DEPARTMENT OF THE ARMY
NEW ORLEANS DISTRICT, CORPS OF ENGINEERS
P.O. BOX 60267
NEW ORLEANS, LOUISIANA 70160-0267

The U.S. Army Corps of Engineers would like to request a modification to the Coastal Zone Consistency Determination C20080112 for Individual Environmental Report 5 titled Permanent Protection System for Outfall Canals, 17th Street Canal, Orleans Avenue Canal and London Avenue Canal, Orleans and Jefferson Parishes, Louisiana. The purpose of the proposed action remains to protect the project area from storm surge-induced flooding through the 17th Street, London Avenue, and Orleans Avenue Canals, while not impeding the ability of the area's internal drainage system to function. The modification for this coastal zone consistency determination resulted from additional analysis for constructability, risk and reliability, cost, schedule, natural environmental impacts, and visual impacts and necessitated a change in the proposed site locations on Orleans Avenue and London Avenue canals.

Coastal Zone Consistency Determination C20080112

2.3 PROPOSED ACTION

Figure 1. 17th Street Canal Proposed Action, Layout Alternative A

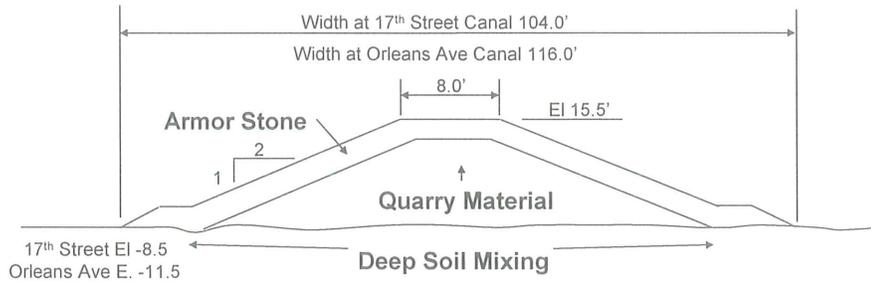
The new pump station could impinge on both banks of the canal, which would require permanent right-of-way (ROW) acquisition of up to 32 acres, affecting residential and commercial property on the east bank and commercial property on the west bank (shown in green on Figure 1). In addition, a temporary construction easement of approximately 4 acres could be required (shown in yellow on Figure 1). Demolition and removal of the existing interim control structure (ICS), and existing levees could be required. During design and construction of the new pump station, efforts will be made to minimize the impacts to residential and commercial business in the project area, so that the final site design could actually be smaller and have fewer impacts on these areas when completed.

Because of the lakeshore location of the new pump station, erosion protection armoring would be required, which could consist of a strip of riprap protection in the canal floor north and south of the new pump station. A breakwater in Lake Pontchartrain, not to exceed 104 feet wide by 600 feet long in size, could be constructed to an elevation of +15.5 ft NAVD 88 to protect the new pump station. A typical cross-section and plan view of the breakwater proposed for the 17th Street Canal is detailed in figures 2 and 3. In this area the lake bottom elevation is -8.5 ft and the water elevation is 1.0 ft. The 17th Street Canal breakwater would require approximately 30000 cubic yards of stone. To construct the breakwater, no dredging of Lake Pontchartrain is required. The estimated construction time frame for the proposed action at the 17th Street Canal is 36 months.

Figure 2. Typical cross section of the 17th Street and Orleans Avenue Canal breakwaters.

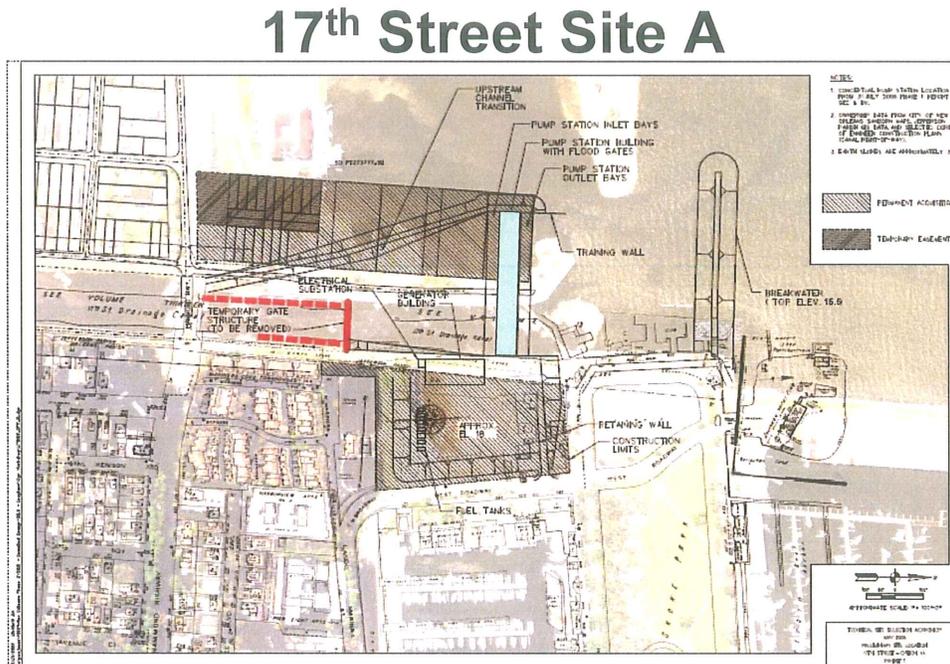
Guideline 5.4 Shoreline modification structures shall be built using best practical materials and techniques to avoid the introduction of pollutants and toxic substances into coastal waters. **This guideline is acknowledged. The breakwater structures that could be constructed at the 17th Street and Orleans Avenue Canals would be constructed using natural rock materials.**

Guideline 5.9 Jetties, groins, breakwaters and similar structures shall be planned, designed and constructed so as to avoid to the maximum extent practicable downstream land loss and erosion. **This guideline is acknowledged. The breakwater structures that could be constructed at the 17th Street and Orleans Avenue Canals would be constructed to minimize impacts to the littoral flow along the southern shoreline of Lake Pontchartrain.**

Figure 4. Orleans Avenue Canal Proposed Action, Layout Alternative B

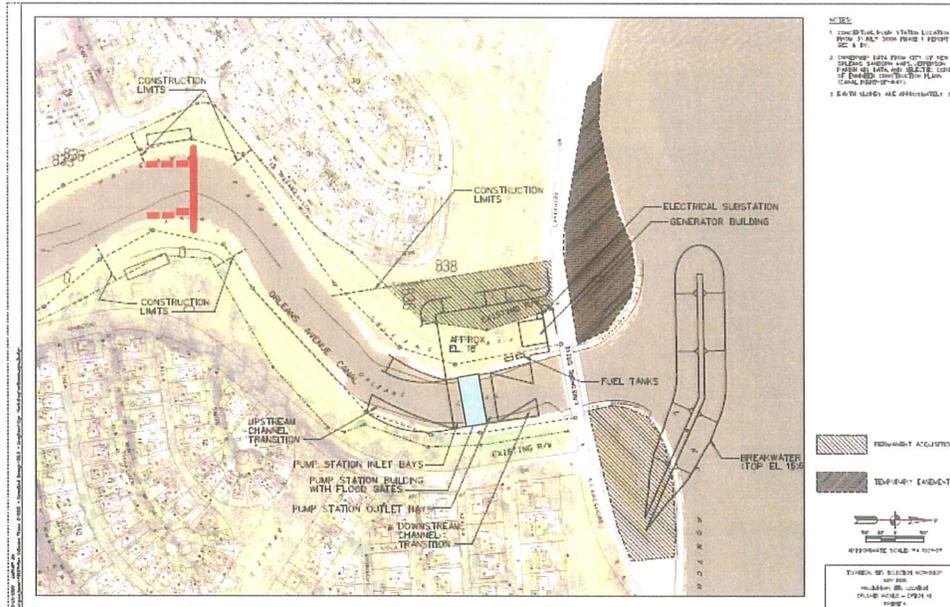
Permanent ROW acquisition of up to 21 acres of property would occur almost exclusively on the west bank of this proposed layout and could include areas that are primarily publicly owned greenspace, rather than privately owned homes (shown in green on Figure 4). A temporary construction easement of approximately 4 acres would be expected (shown in yellow on Figure 4). The ICS south of this site would be removed after the pump station construction is complete.

Because of the lakeshore location of this pump station, a substantial volume of erosion protection armoring would be required; also, a strip of riprap protection would be placed in the new canal floor, both immediately north and south of the new pump station. A breakwater in Lake Pontchartrain, approximately 116 feet wide by 700 feet long could be constructed to an elevation of +15.5 NAVD 88. A typical cross-section and plan view of the breakwater proposed for the Orleans Avenue Canal is detailed in figure 2 and 5. In this area the lake bottom elevation is -11.5 ft and the water elevation is 1.0 ft. The Orleans breakwater requires approximately 43400 cubic yards of stone. To construct the breakwater all access would be from the land and no dredging of Lake Pontchartrain is required. The estimated construction time frame for this layout alternative is 36 months.
